Hudson River PCBs Superfund Site

Date: November 8, 2006

Subject: Maintenance of Pre-existing Shoreline Configuration and River Bathymetry

Figure 8b GE Proposed Backfill

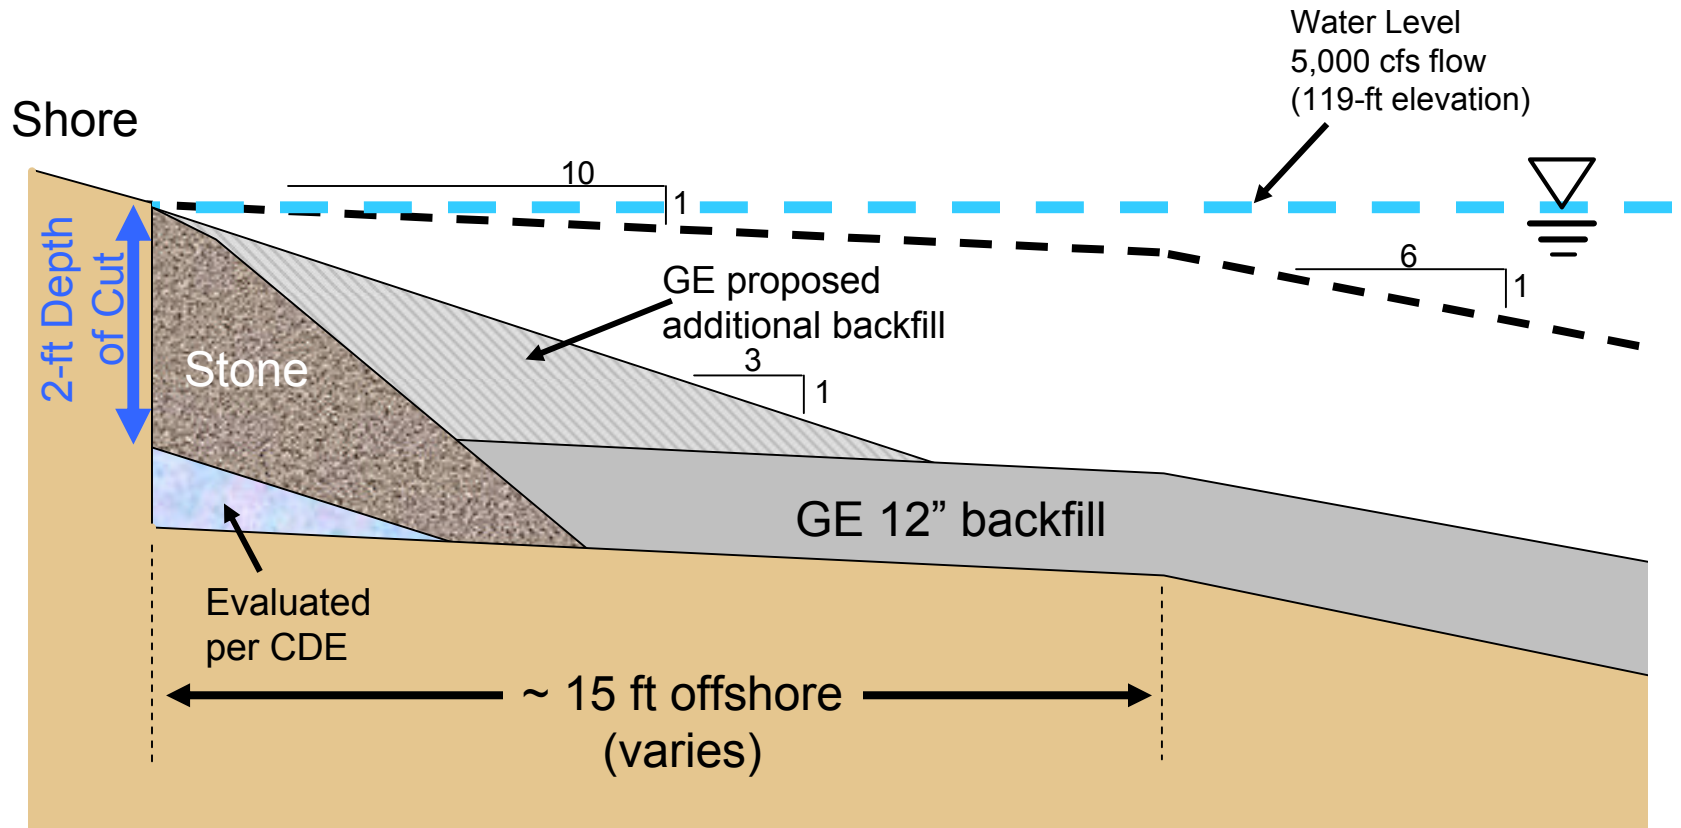
This observation has important implications for the reconstruction of the shoreline area. Given the energies available to move sediments in these areas, attempts to replace these shoreline areas at slopes steeper than 10:1 would require backfill materials much coarser than what is currently in place. Construction of such a slope would likely create a surface feature along the banks whose sediment texture and slope are coarser and steeper than what exists now. Given the daily oscillation in flow, this structure would be exposed daily under typical flow conditions.

Shoreline cross section examples. An example pre-dredge shoreline cross section is shown in Figure 8a, illustrating the typical shallow near-shore slope of approximately 10:1 out to the 117.5-ft elevation where the slope changes to approximately 6:1. The figure also represents the condition where the depth of contamination is greater than 2 feet at the shoreline; this situation would require a 2 foot initial cut followed by a cut on a 3:1 slope. Figure 8b depicts the same shoreline configuration subsequent to dredging with the backfilling proposed by GE in their April 28, 2006 letter from John Haggard to Doug Garbarini, as well as in Figure 2 of GE's August 4, 2006 Statement of Position. Figure 9a provides a similar cross section, except that the depth of contamination is less than 2 ft so the depth of cut and the depth of contamination are the same at the shoreline. Figure 9b depicts the cross section with GE's proposed backfill, similar to the illustration shown in Figure 8b.

Recommendation. Figures 8c and 9c depict the recommended placement of backfill (or backfill/cap if capping is implemented) to maintain the pre-existing shoreline configuration and river bathymetry in the backfilled or backfilled/capped area. Figure 8c depicts backfilling/capping recommended in the situation where the DOC is extrapolated to be greater than 2 feet at the 5,000-cfs shoreline (as illustrated in figure 8a). Figure 9c represents backfill/cap recommended in shoreline areas where the depth of contamination lies between 1 ft and 2 ft.⁴ These figures illustrate how the bathymetry should be restored to the 117.5 contour which approximates the 1Q3 flow. Beginning at the 117.5 elevation, backfill would be placed on a 3:1 slope until it intersects the 1 ft of backfill material typically required in areas not subject to this determination. This wedge of additional backfill is needed to prevent slumping on the river side edge of the bathymetric restoration of the near shore area. The change in slope at an elevation of approximately 117.5 ft would require a supporting wedge that would nominally extend horizontally to 12 ft beyond this elevation, given the median 6:1 slope.⁵
